Wireless Ethernet Compatibility Alliance

2.4.2 CUBE Must Substantiate Claims Made to the Commission

Figure 2.4.4-1 Subset of Rx Desensitization Data (10^{-5} BER Threshold) Demonstrates Interference is Most Severe from Partially Overlapped Channels

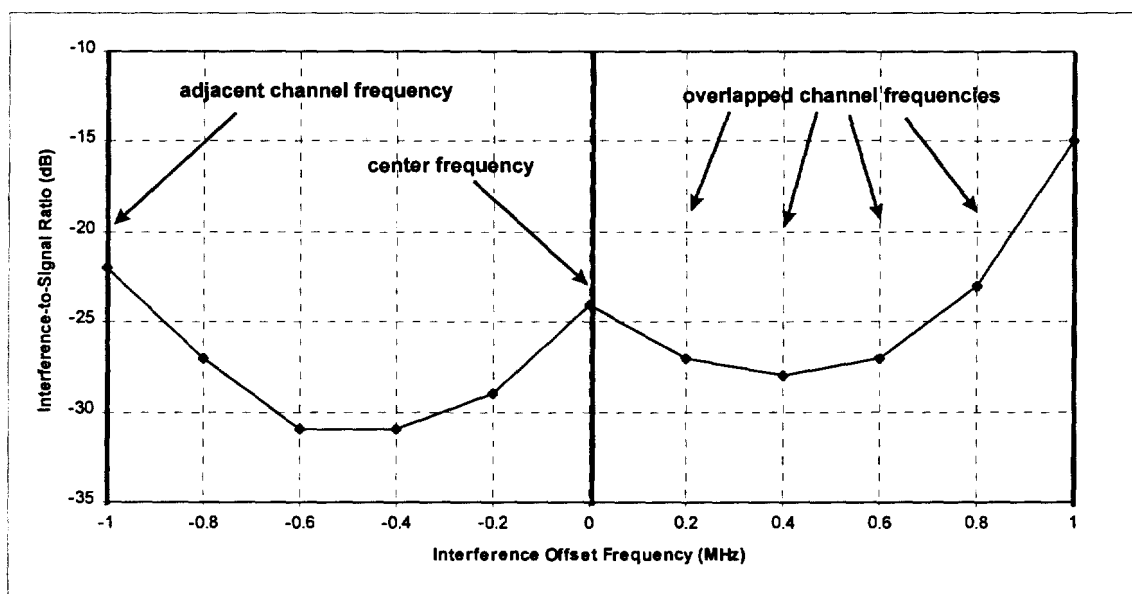
“The basis of the opponents argument is the response characteristic of the analog discriminator to signals offset from the tank circuit center frequency. Using a combination of oversimplified analysis and measured data on existing FH products, they assert that partially overlapping channels can have signal-to-interference ratios that are up to 7 dB worse than fully overlapping co-channel interference. They further present dire eye diagrams and dramatic tables of results to illustrate serious interference problems. Notably, all of these are made with the channel filtering removed. No one, however, even would consider building a wireless LAN with no channel filtering.”

The foregoing comment is one of many statements that demonstrate CUBE's failure to understand the analysis submitted by Intersil on the issue of partially overlapping FHSS channels. That analysis [1] presented receiver desensitization data for an Aironet IEEE 802.11 FHSS product. The measurements were taken in accordance with procedures specified in the IEEE

802.11 WLAN Standard. Figure 2.0-2 of that report clearly indicated that the FHSS receiver tested was, in fact, 7 dB more sensitive to interference from a partially overlapped interferor. That figure is reproduced below as Figure 2.4.4-1.

Some features of the data shown in Figure 2.4.4-1 are worth mentioning. The device under test is an Aironet 4FSK receiver capable of 2 Mbps. It has very good channel filtering. Note that the receiver is actually less sensitive to interference at offset frequencies of ± 1 MHz corresponding to a full channel offset (Adjacent Channel Interference, or ACI), than to co-channel interference (CCI). Referring to Table 1 of the CUBE Reply Comments, note that the Proxim OpenAir radio tested is actually *more* sensitive to ACI than CCI. In this manner, the Aironet radio is superior to the Proxim OpenAir radio used by CUBE in its own testing of the effects of interference from offset frequencies.

Figure 2.4.6-1 Analysis of WBFH Interference Effects Using Modified Assumptions

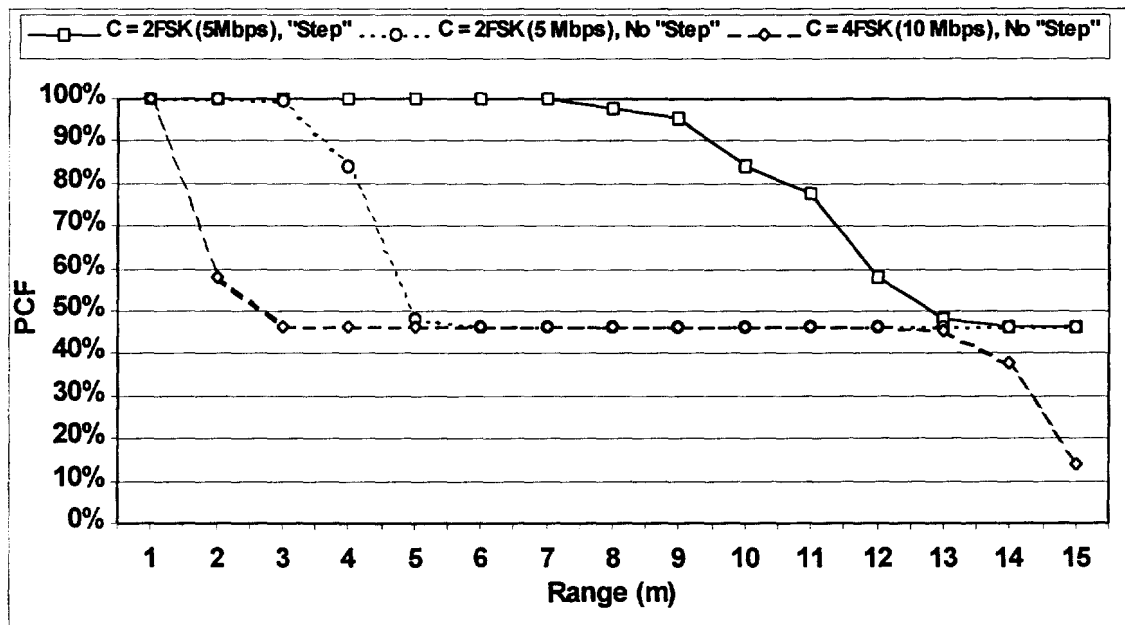
“The answer to this question [the effects of overlapped channels] is apparent from the extensive simulation work of the HomeRF Technical Committee, which was presented to the Commission prior to issuance of the NPRM. The HomeRF Group analyzed the effects of partially overlapping channels on WBFH devices while making far more pessimistic assumptions than this miniscule 3 dB discriminator effect. To be conservative, the HomeRF Technical Committee assumed both a uniform distribution of energy in the WBFH transmit channel and that interfering networks would be active at the 5 MHz hopping channel width 100% of the time.

Despite the use of these highly pessimistic assumptions (which dwarf the 3 dB discriminator effect), the HomeRF group found that throughput degradation for detached family homes with 5 MHz WBFH systems in both the target home and all surrounding homes in the neighborhood was essentially zero.”

In order to demonstrate the degree to which the HomeRF results rested upon unrealistic assumptions, WECA has reproduced the results of the HomeRF spreadsheet analysis of the Multi-Family Dwelling Scenario based on the following assumptions:

The results of the WECA spreadsheet analysis are shown in Figure 2.4.6-1. The curve designated as “2FSK (5Mbps) Step” indicates the estimated level of interference under the assumptions employed by the HomeRF Technical Committee. In order to show the dramatic effect associated with two of the HomeRF assumptions, WECA repeated the spreadsheet simulation under the same conditions, with the exception that the aforementioned “step” attenuation of 12 dB for the peripheral interfering network is removed. These results are reflected

in the curve labeled "2FSK (5 Mbps) No Step". Note the remarkable difference in the predicted levels of interference.

Note that the foregoing spreadsheet analysis is identical to the one performed by the HomeRF Technical Committee. The only modifications are those which were performed to demonstrate the impact of some of the more arbitrary assumptions used by HomeRF in their earlier presentation to OET. These modifications were limited to the removal of the "Step" attenuation for the interference sources, and analysis of the effects of interference from peripheral

Figure 2.8.1.1-1 Phasor Diagram of Signal and Interference (see Fig. 6-27, Stremler)

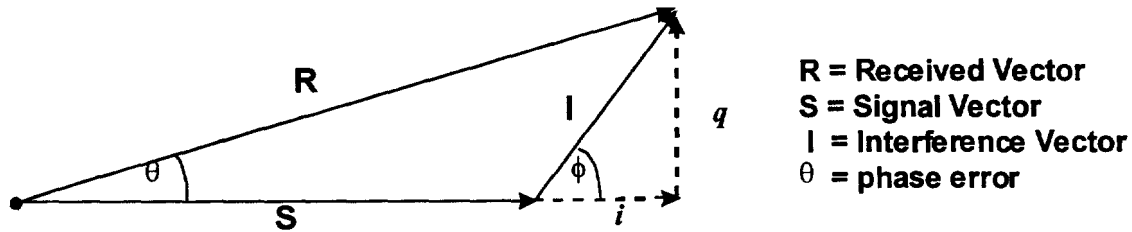
Misapplication of the Theoretical Basis: The equations are taken out of context and are not applicable in many places within documents submitted by Intersil Corporation. For example, an equation was shown that states that the noise spectral density at the output of an FM demodulator is proportional to the square of the frequency offset. In extracting this equation from the textbook derivation (and it appears in numerous references), two significant assumptions were ignored:

- i.) The equation was derived specifically for the case of band-limited white noise; as Stremler [7] states, "...if one assumes a white noise spectral density for the discriminator input, the output noise spectral density will be parabolic."*
- ii.) Resulting "signal-to-noise" ratios are only valid for the case where the desired signal is much, much larger than the "noise" signal. As stated in the same reference [8] used by Intersil, "[the equation for output SNR] is valid only if the discriminator input SNR is sufficiently large to result in operation above threshold."*

In other words, the squared magnitude response results from a specific set of assumptions that are not valid in this case; analytical results are difficult to derive in low SNR or SIR (signal to interference ratio) cases because of threshold effects. As Stremler [7] states, "Because this [threshold] effect occurs when the noise and signal levels are comparable, it is more difficult to analyze than the high signal-to-noise case."

The above comment of CUBE is wrong. The discriminator response (in proportion to the square of interference frequency offset) does not depend on either a high SIR ratio or on a white noise spectral density at the discriminator input. Separate responses to both issues are presented in the following paragraphs.

The issue of direct relevance is whether the output noise power at the discriminator output is proportional to the square of frequency offset for a narrowband interference source. In Stremler's discussion of this issue, the resulting instantaneous frequency error is characterized by analyzing the rotation of the interference vector (I) relative to the signal vector (S).

The rate of rotation of interference vector (I) relative to signal vector (S) is equal to frequency offset (Δf) between desired signal and interference:
